PRIVATE WATER DISTRIBUTION SYSTEM IMPROVEMENTS

WSU INNOVATION CAMPUS APARTMENT

PROJECT NO. 2015PPW

**AS BUILT PLANS (LINE 2 ONLY)
CONTRACTOR: MIES CONSTRUCTION
SUPERINTENDENT: ALBERT WILLIAMS
FOREMAN: DOUG GOSSER
INSPECTOR: JACOB MORRIS, SCHWAB EATON
PDF BY: JCM 11/17/16**

TITLE SHEET

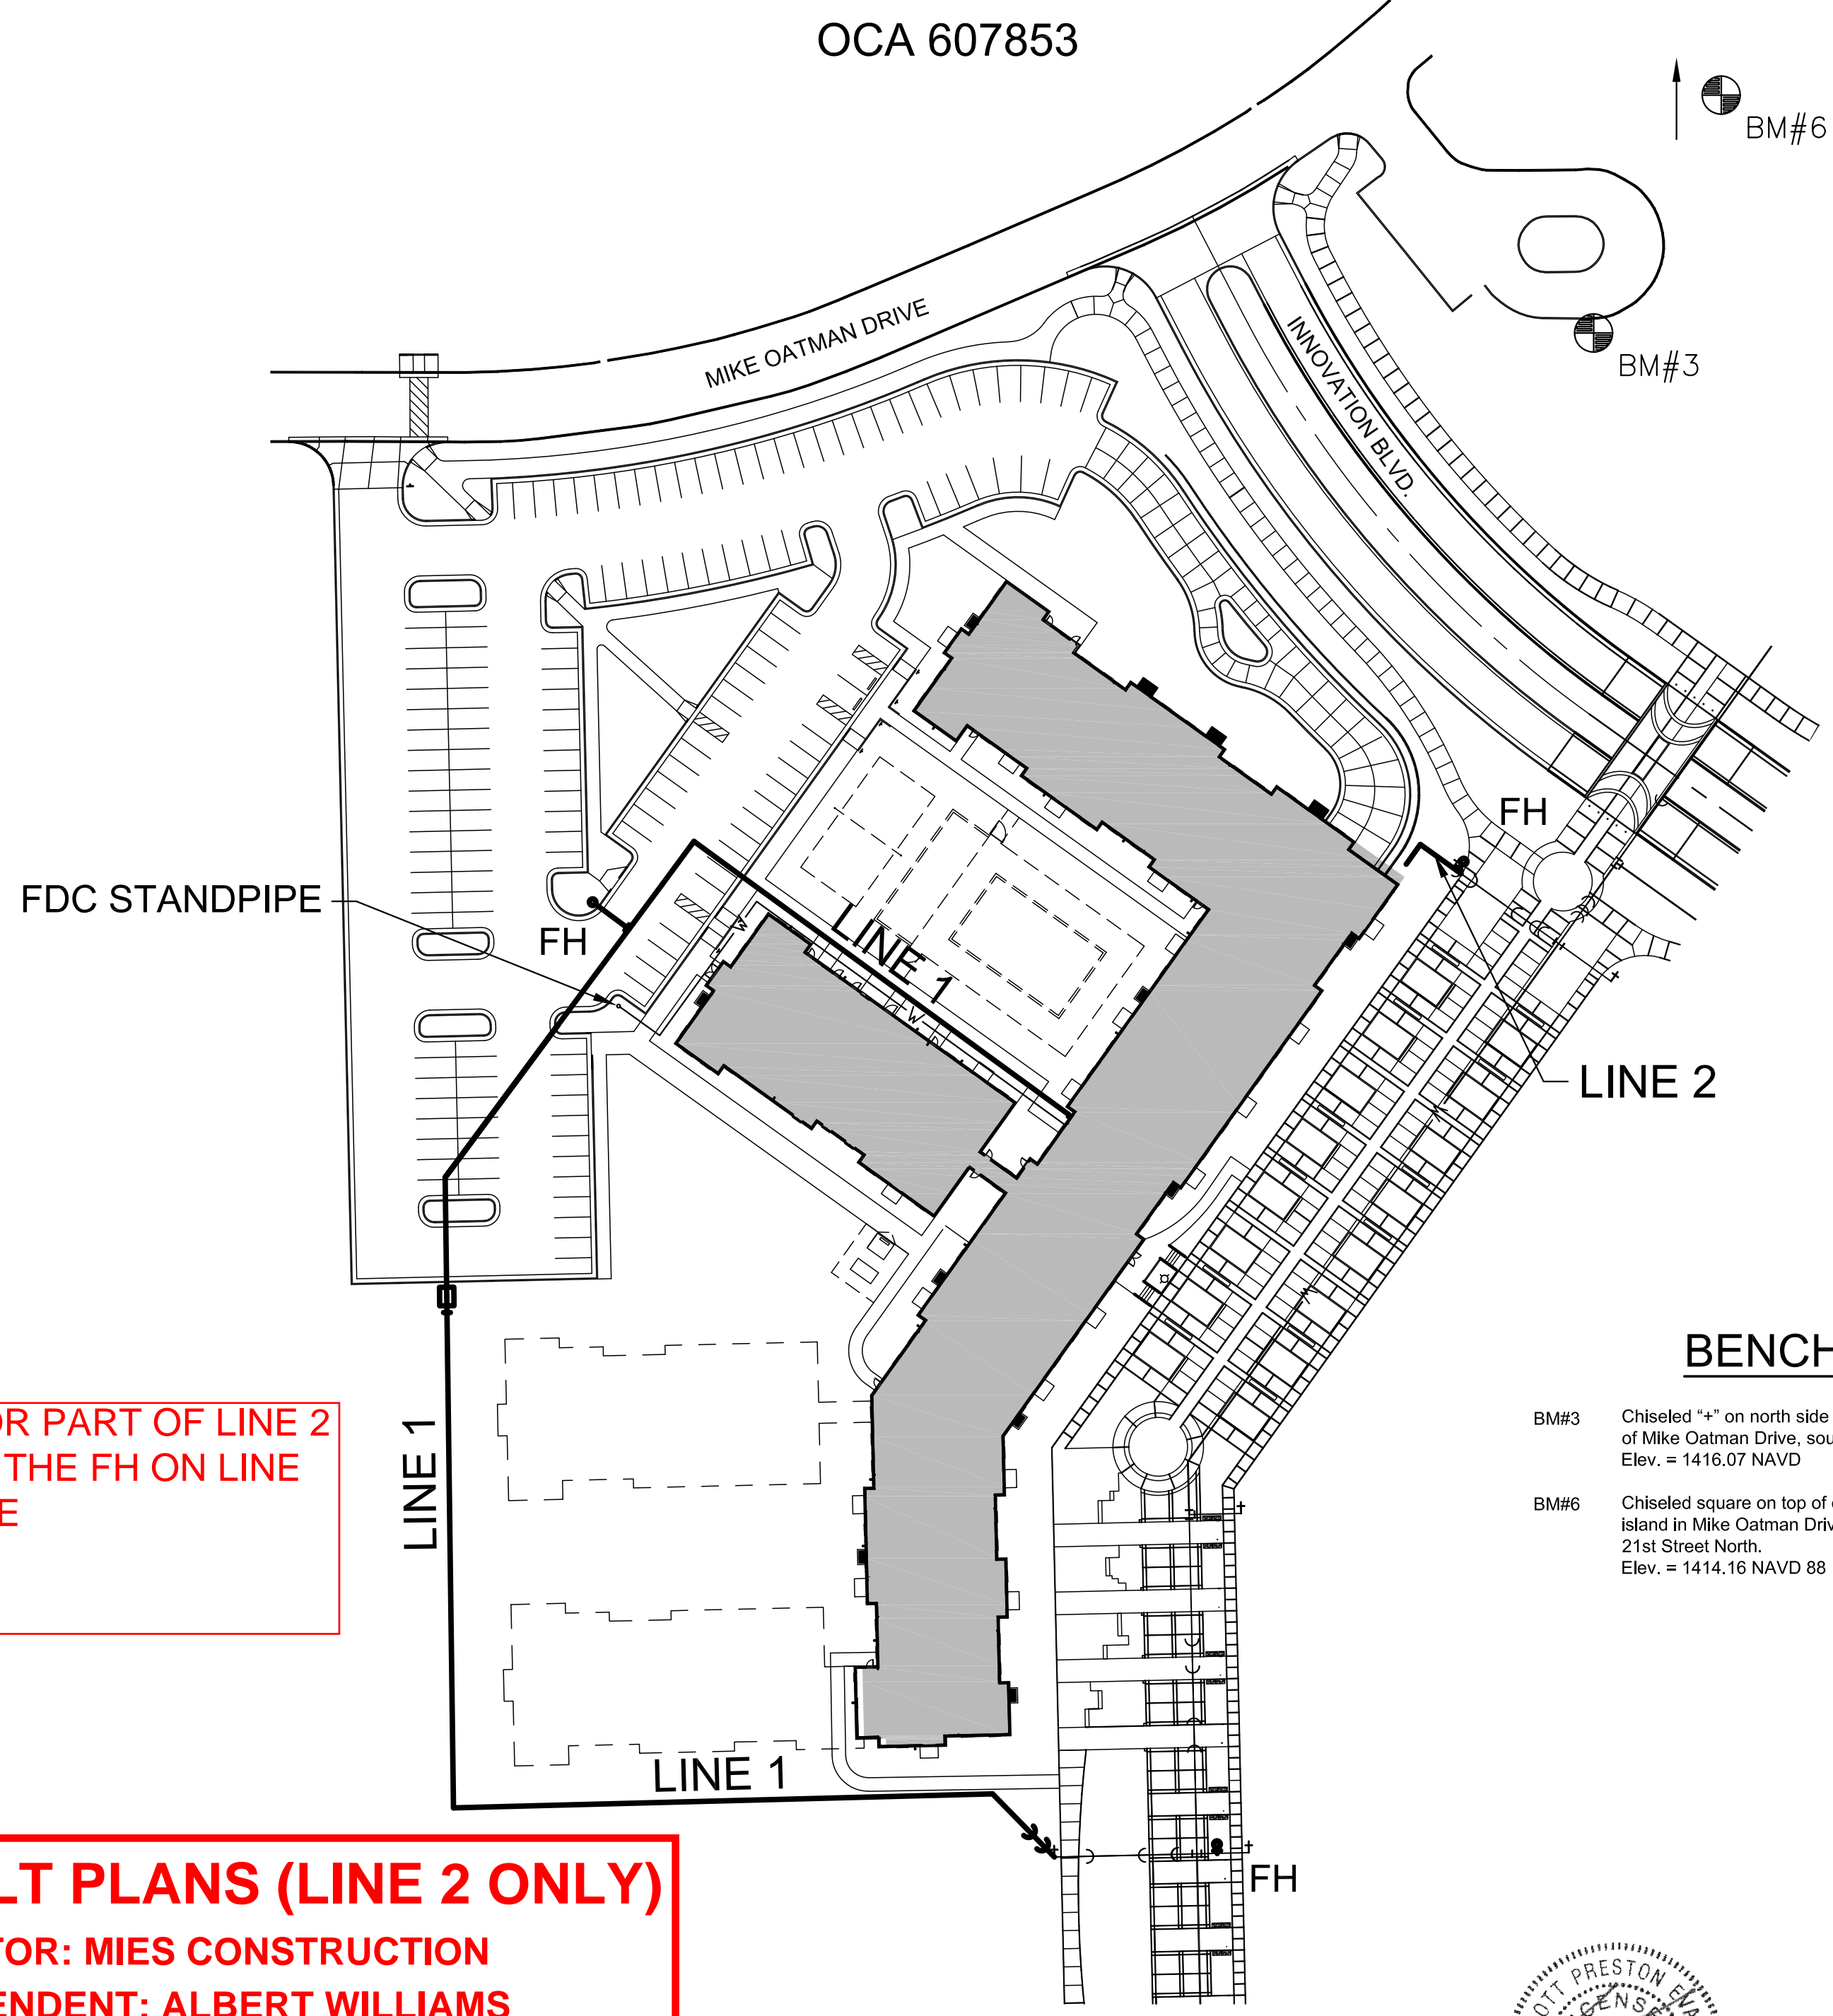
PARTICAL FOR PART OF LINE 2 ONLY, ONLY THE FH ON LINE IS COMPLETE

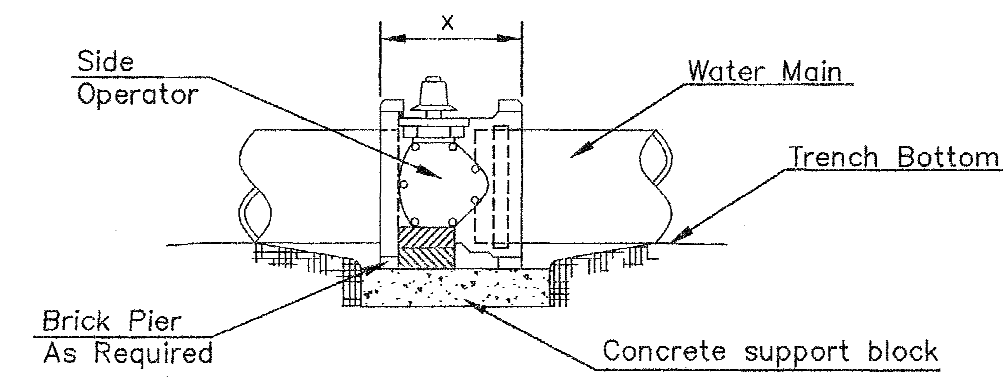
NOTE:
ONLY FH @ STA. 9+97.75, LINE 2
COMPLETED AT TIME OF AS-BUILT

WATER LINE 2

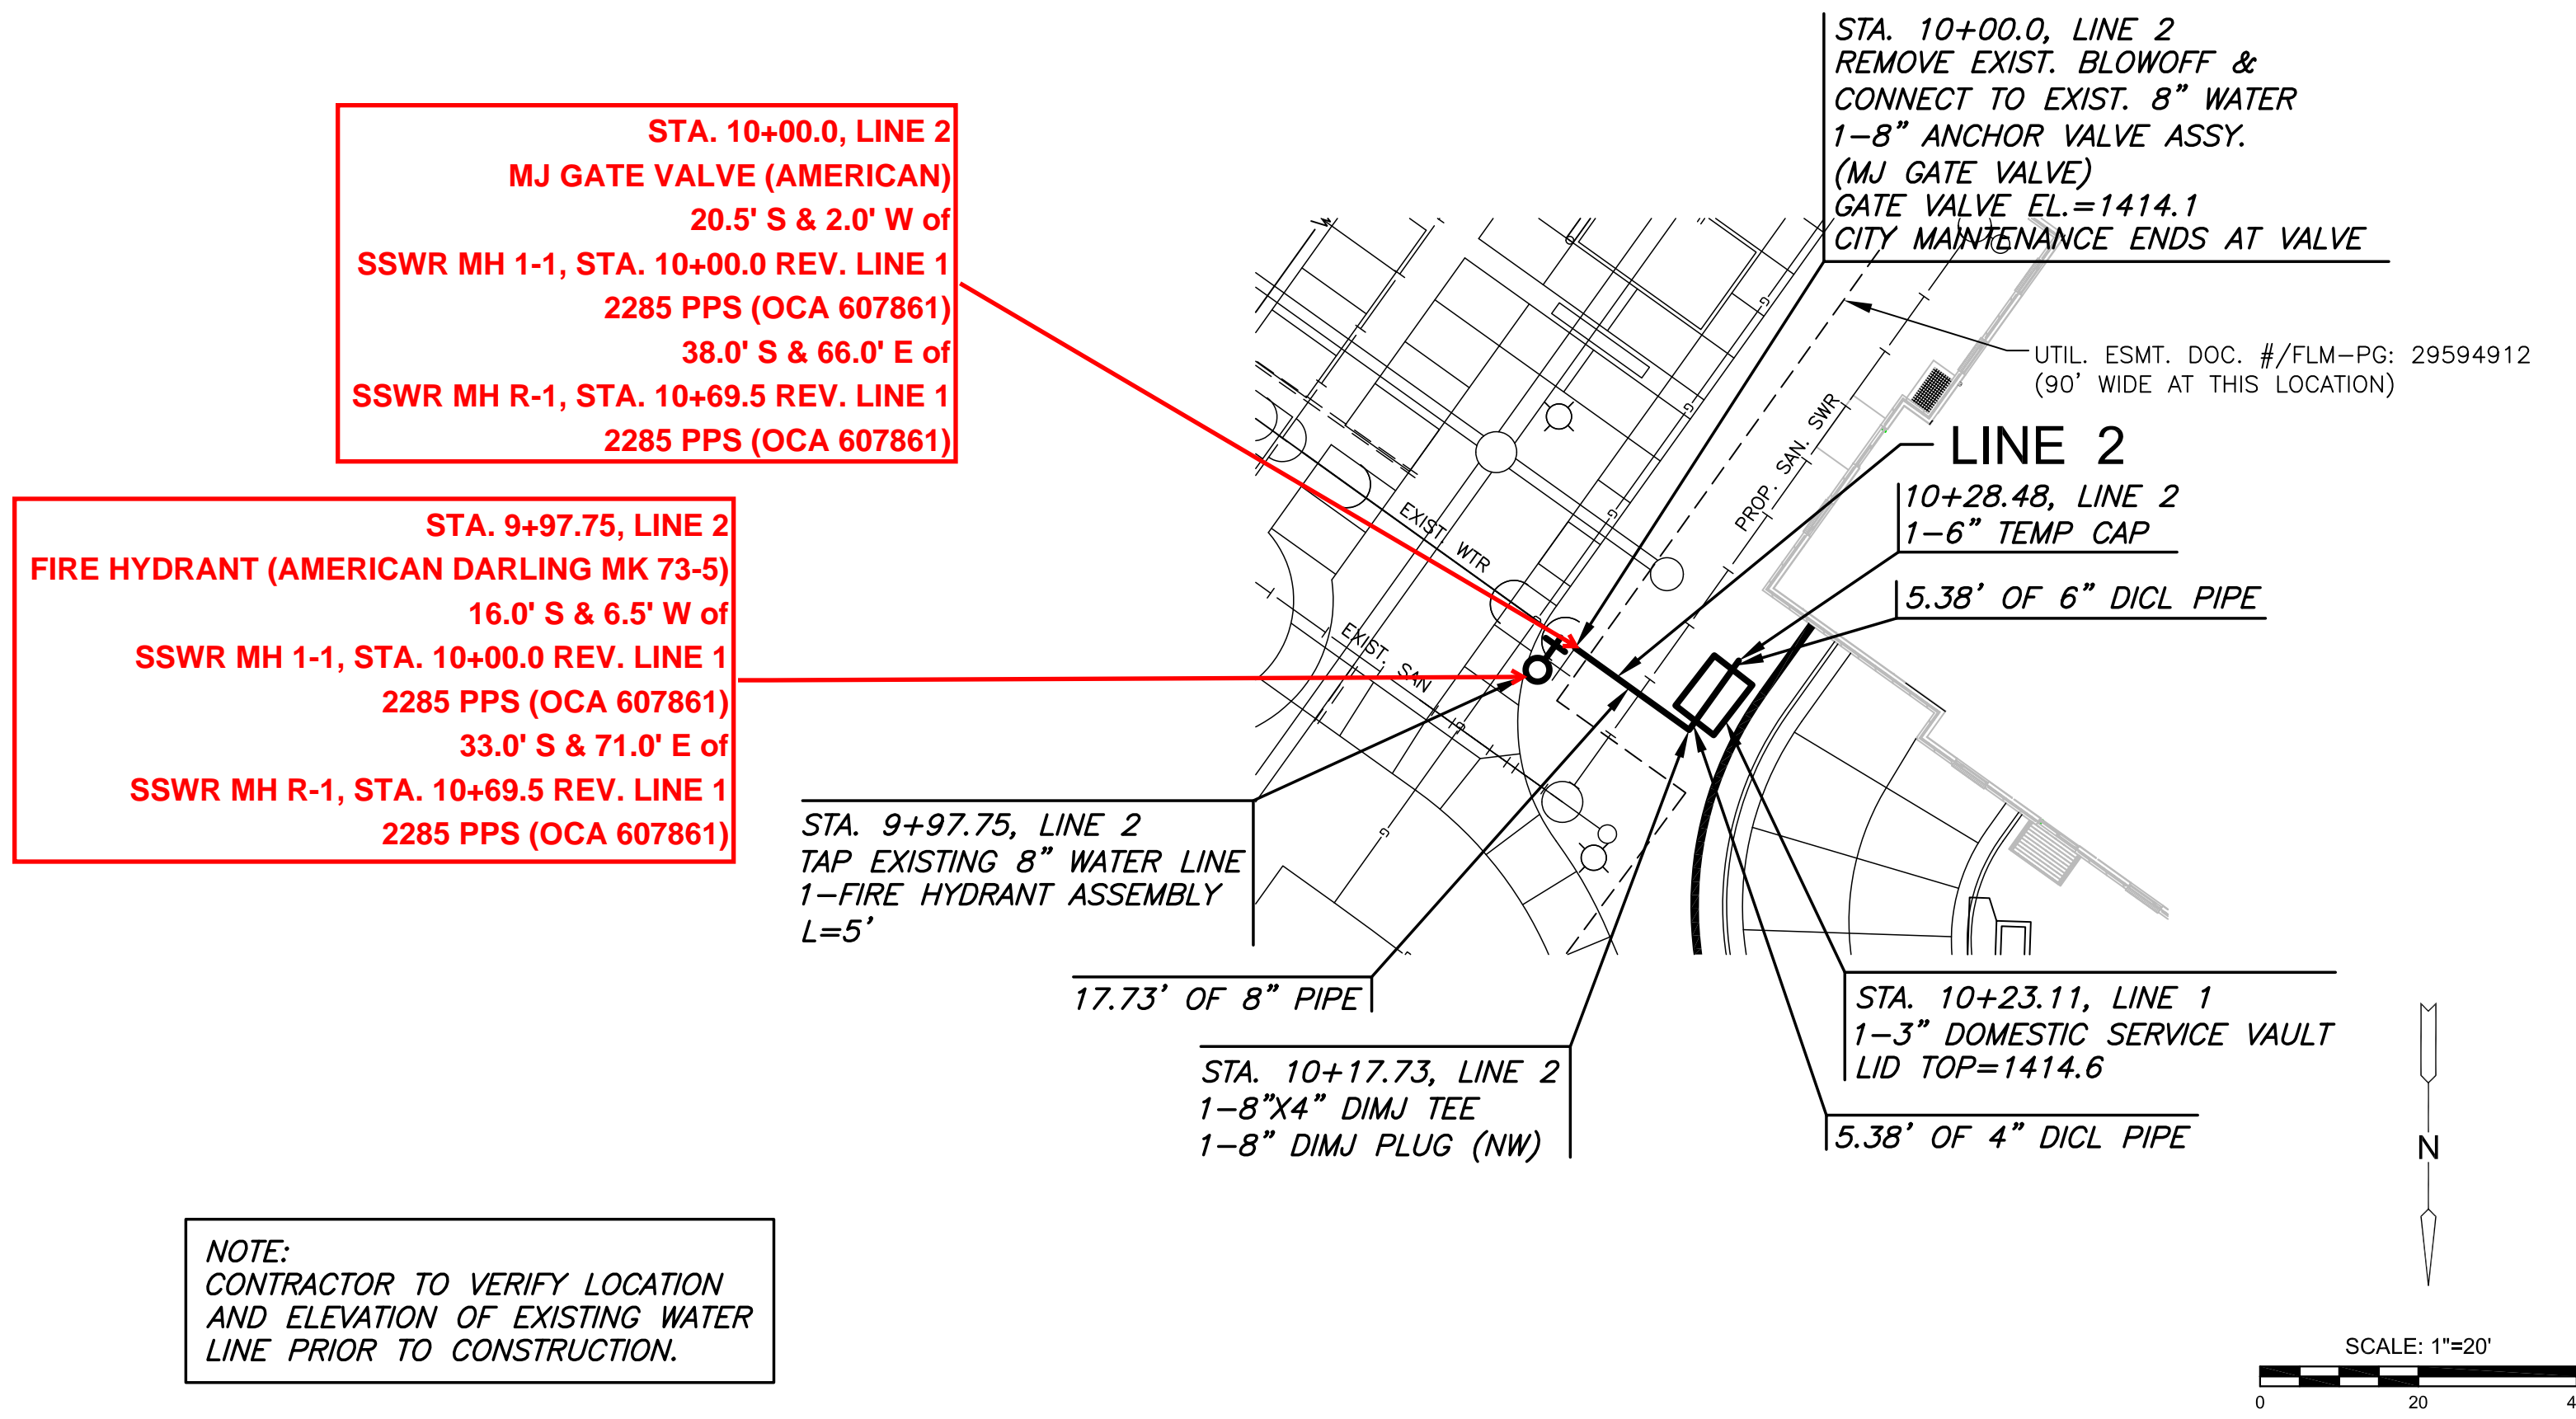
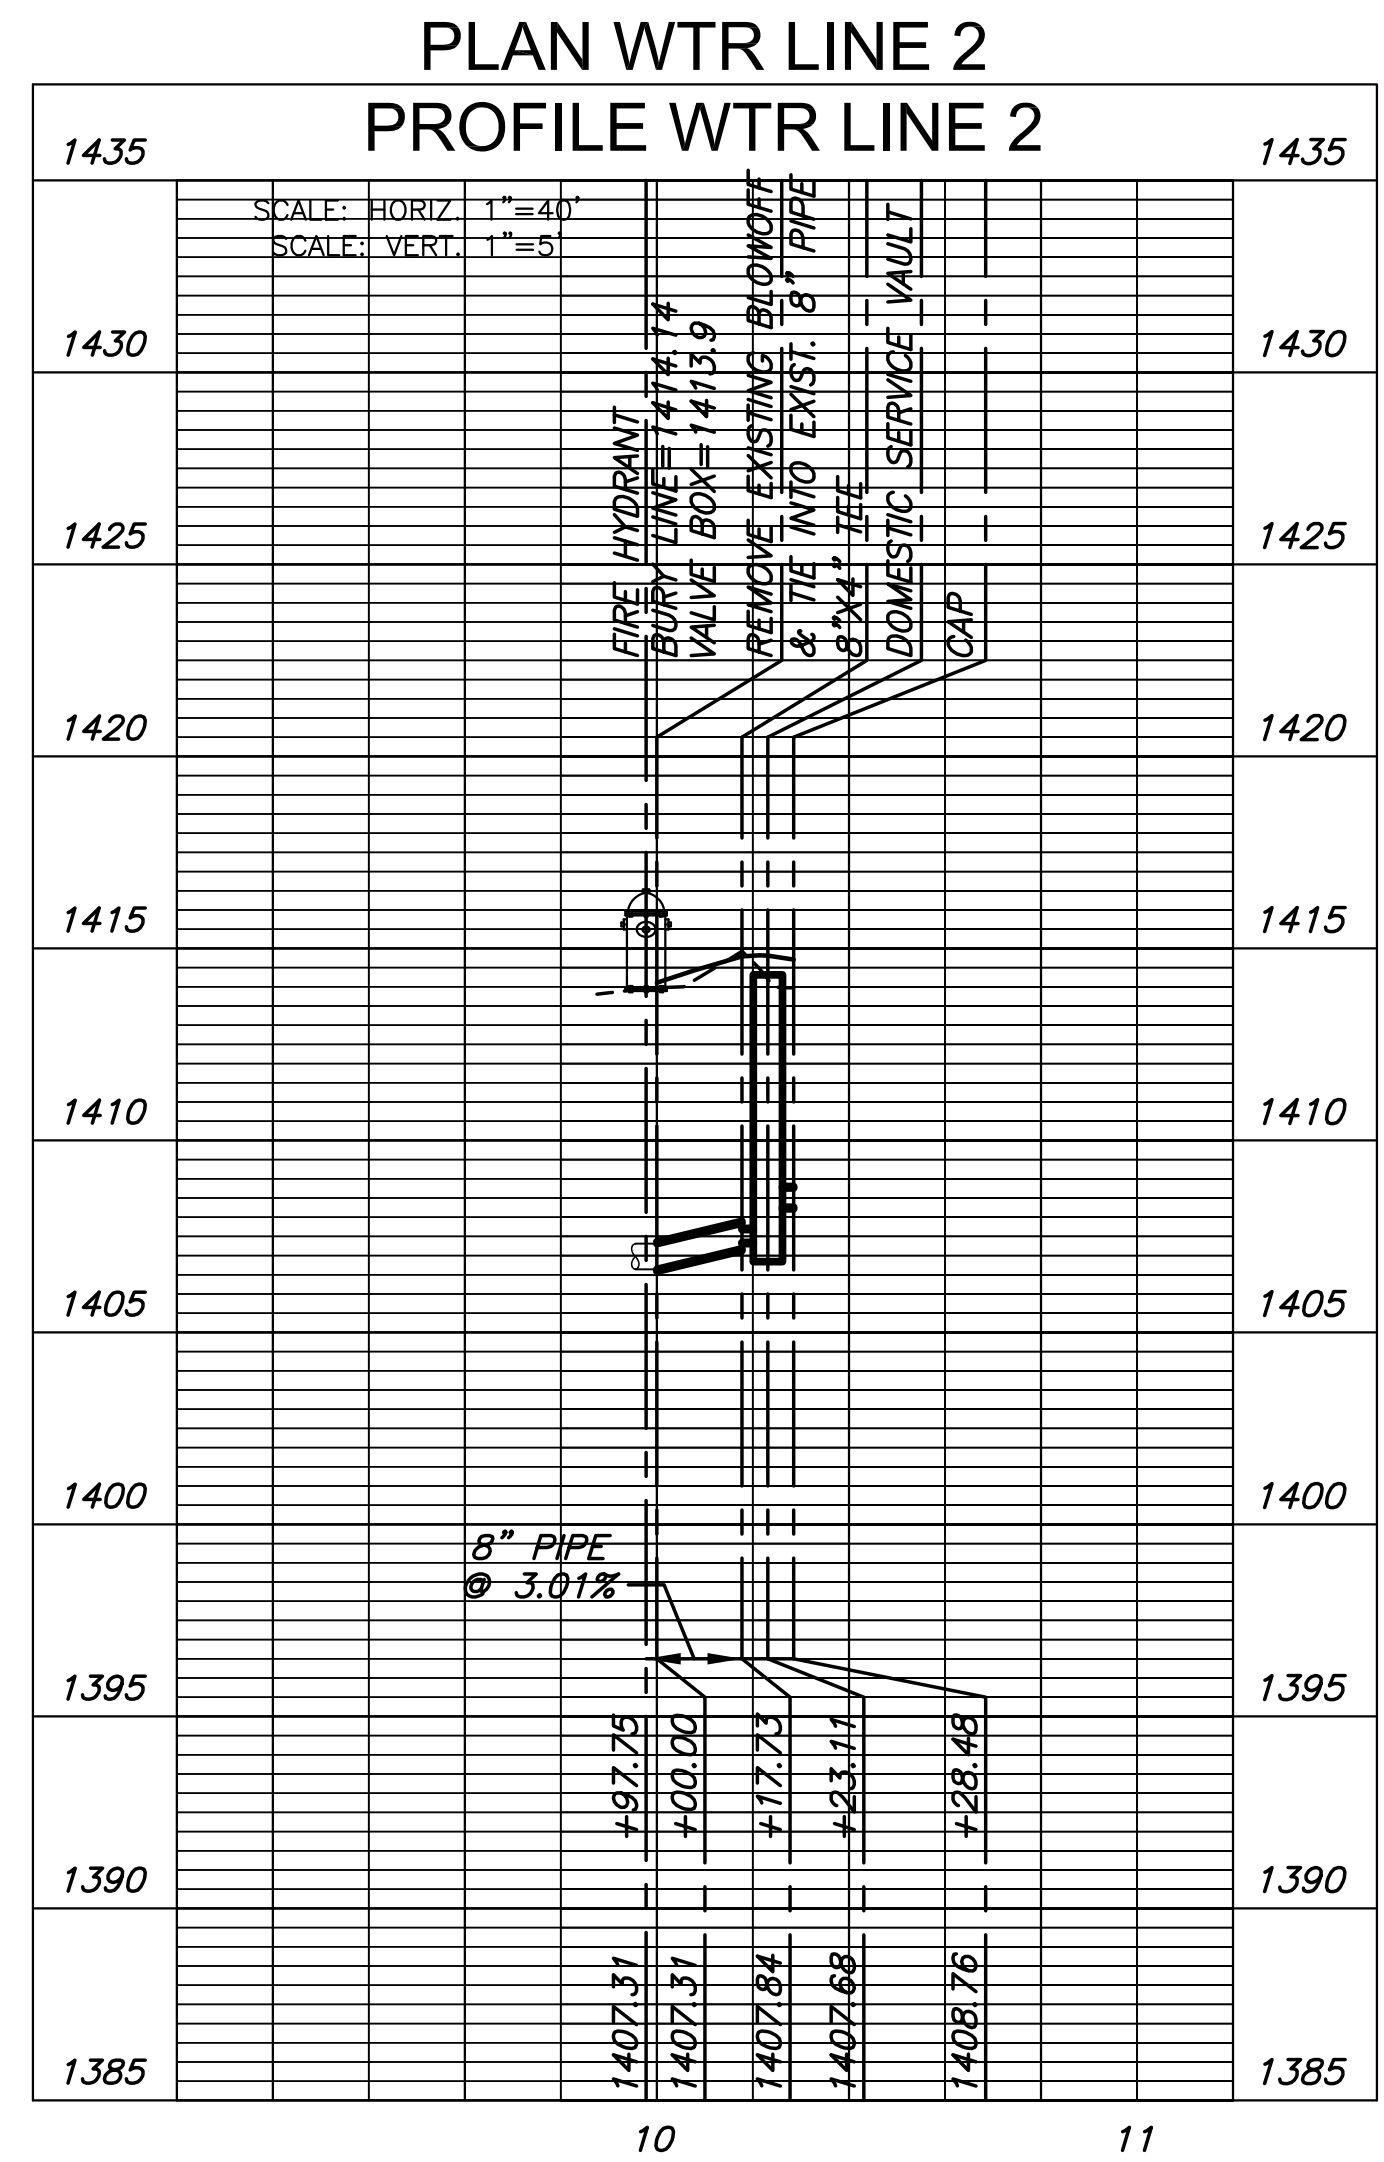
NOTE:
**LINE 2 ONLY COMPLETED FROM
 FH @ STA. 9+97.75 TO GV @ STA. 10+00.00
 AT TIME OF AS-BUILT**

BUILT TO PLAN (AS NOTED)
